**STAFF REPORT 10-09-2024 REGULAR MEETING**

**APPLICATION NUMBER: HDC2024-00538**

**ADDRESS: 4881 STURTEVANT**

**SCOPE: ALTER PORCH, CONSTRUCT DECK (WORK COMPLETED WITHOUT APPROVAL)**

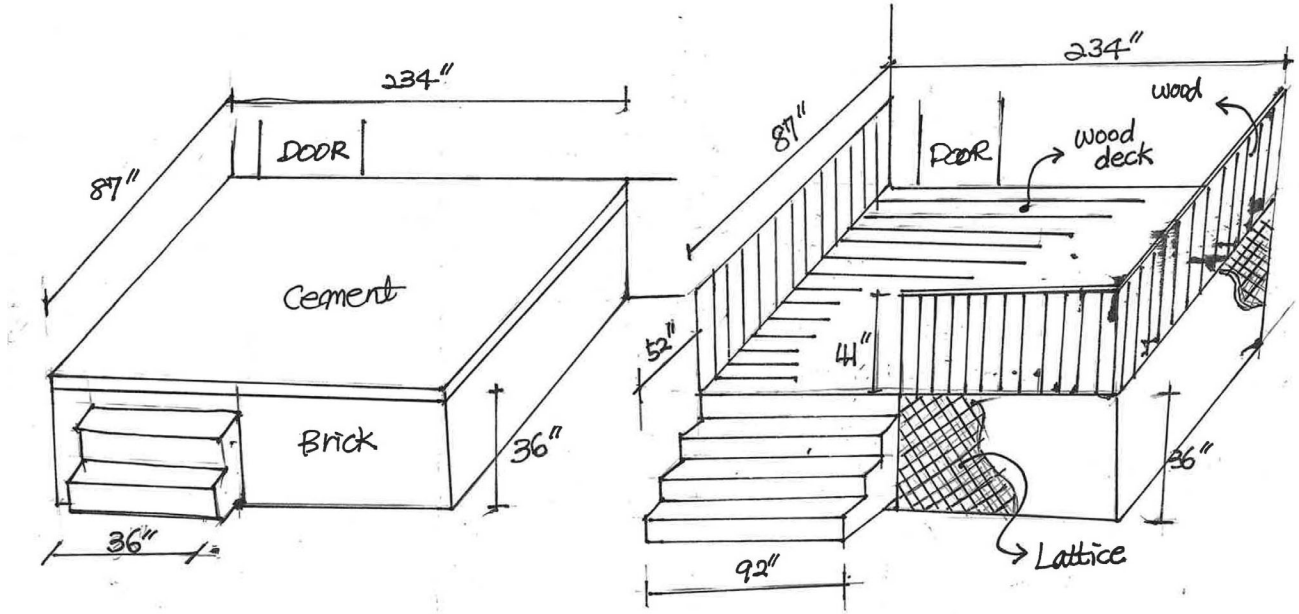
- The original porch, like many similar examples in the district, was a concrete platform supported by brickwork matching the house. A short flight of concrete steps leading up from grade was framed by a pair of modest brick wing walls, also capped by concrete or stone. The applicant's "before" sketch does not show the wing walls, which were present as late as 2020.

- A "backyard"-styled deck of this style/material is not compatible with the period design of this vernacular English Revival house, especially at the historic and highly visible front façade, and disrupts the historic character of the house and the district. The deck as completed has generic characteristics like outboard-baluster railings, raw dimensional lumber, modern railing heights, and x-cross latticework, all of which bear no relation to the authentic character of the subject property. The approach

steps are much wider and more obtrusive than the original steps, and greatly detract from the expression of the façade.

- The deck is of a standard recreational/contemporary design built of “off the shelf” parts, perhaps suitable for a backyard, but makes no effort to integrate into the historic design of the house, contrary to historic standards and guidelines. In staff’s opinion, the wood deck should be removed and a brick/concrete porch of compatible design rebuilt.

- The former brick and concrete front porch is a distinctive character-defining feature of the house and district, and should be repaired or replaced to match
- The proposed deck is of a standard recreational/contemporary design built in an incompatible modern/utilitarian character, using outboard-baluster railings, raw dimensional lumber, modern railing heights, and x-cross latticework, and makes no effort to integrate into the historic design of the house and district.

Staff therefore recommends that the Commission issue a Denial for the work, as it does not meet the Secretary of the Interior’s Standards, specifically Standards 2, 5, and 6;
